**PICDEM™ Lab Development Board Errata**

The PICDEM Lab Development Board you have received conforms functionally to the information provided in the accompanying user's guide (41369A), except for the anomalies described below.

**FIGURE 1: UPPER RIGHT CORNER OF PICDEM™ LAB DEVELOPMENT BOARD WITH TRACE TO BE SEVERED**

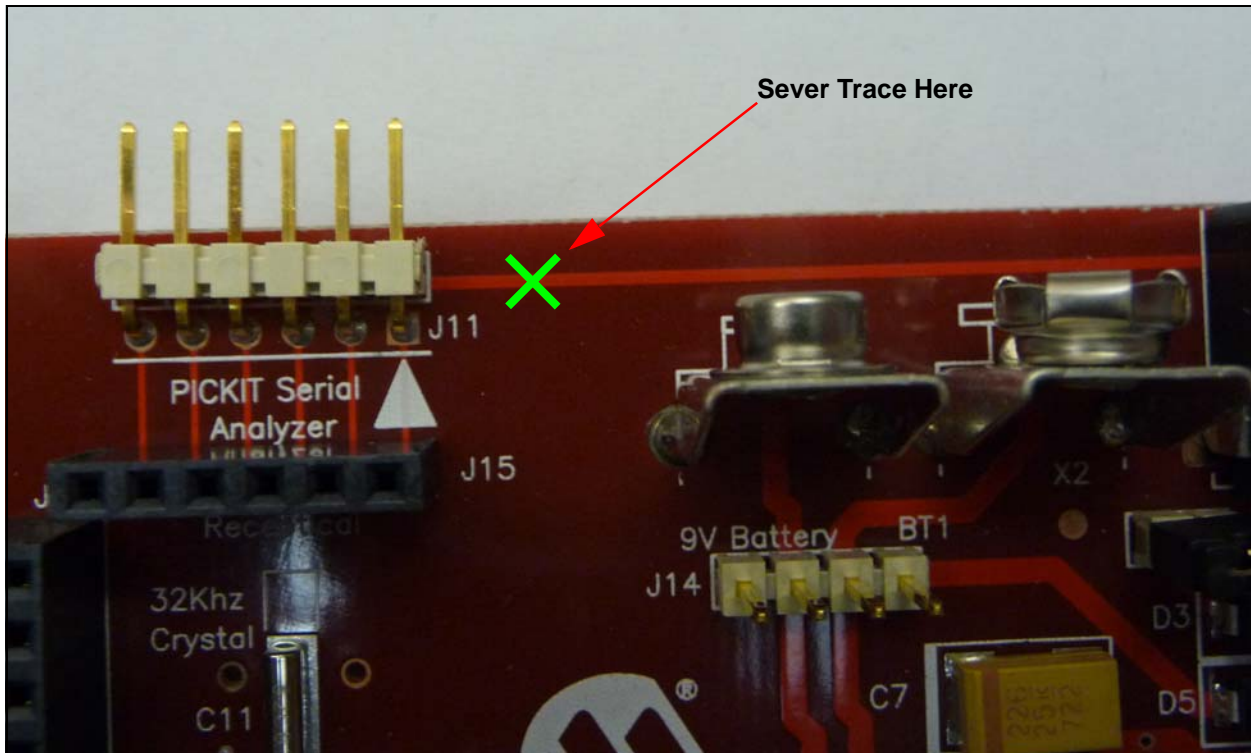
- Issue: Damage can occur to the PICKit™ Serial Analyzer when the PICDEM Lab Development Board is powered by a 9V battery or 9V power supply.**

**Details:** When the VDD connector on the PICKit Serial Analyzer header (J11) is connected to the 9V source on the board, significant damage can occur to the PICKit Serial Analyzer.

To fix this issue, the user will need to sever the trace connecting the VDD pin of J11 to the 9V source.

Locate the trace as indicated in Figure 1. Using a sharp tool, such as a craft knife, carefully cut the trace.

FIGURE 2: SEVERED TRACE ON THE PICDEM™ LAB DEVELOPMENT BOARD

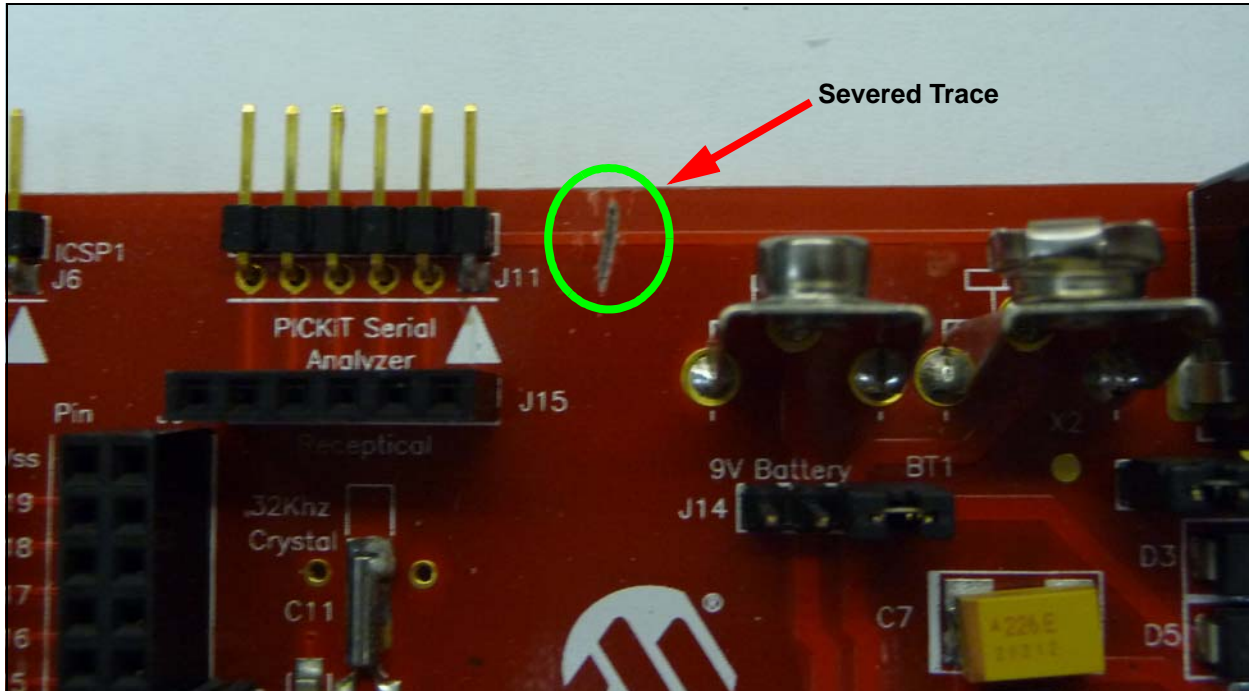
The trace should now resemble Figure 2.

FIGURE 3: PROPER OHMMETER PROBE PLACEMENT TO CHECK THE OFFENDING TRACE

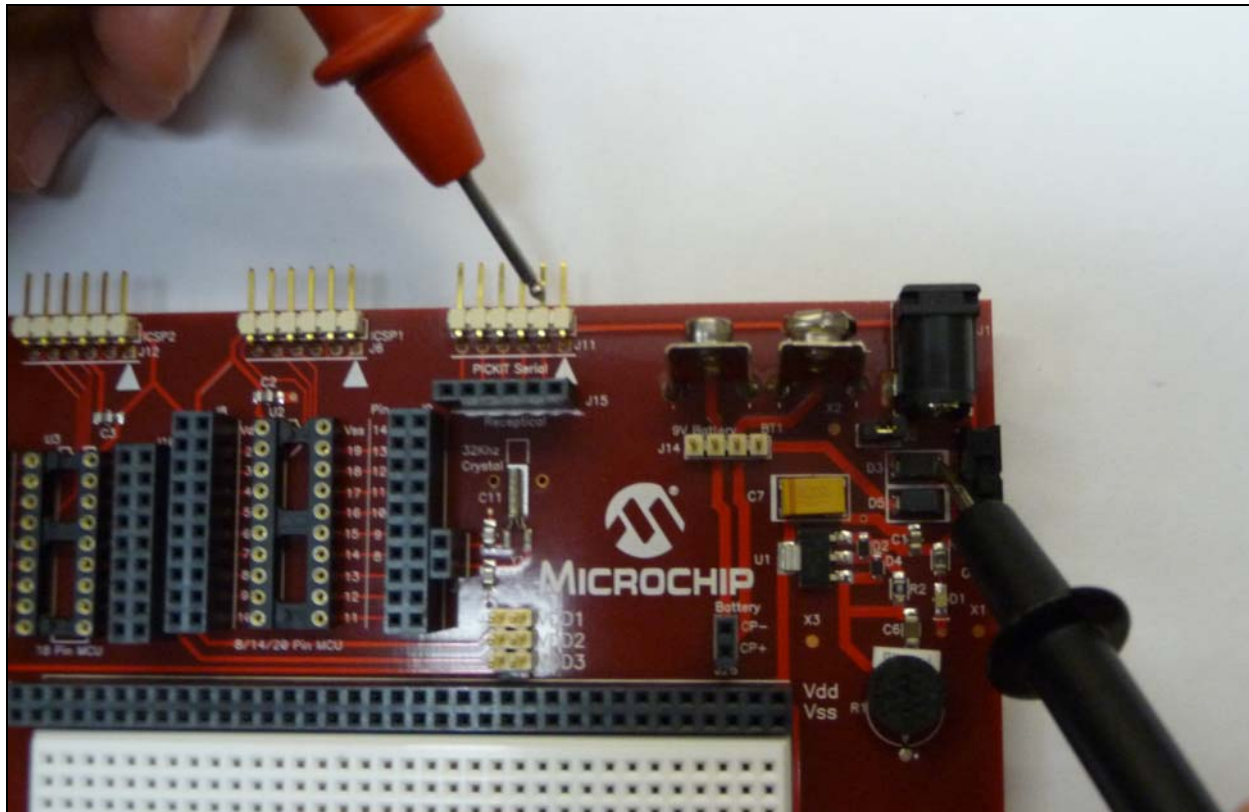
It is recommended that an ohmmeter is used to verify that the cut has severed the trace. To verify, connect one probe of the ohmmeter to the VCC node and the second to pin three of the PICKIT Serial Analyzer connection header (J11), refer to Figure 3. The Vcc node

can be found by placing one probe on the right most pin of either D3 or D5, found on the upper right side of the PICDEM Lab Development Board next to the PWR ON switch. A successful repair will indicate an open circuit.
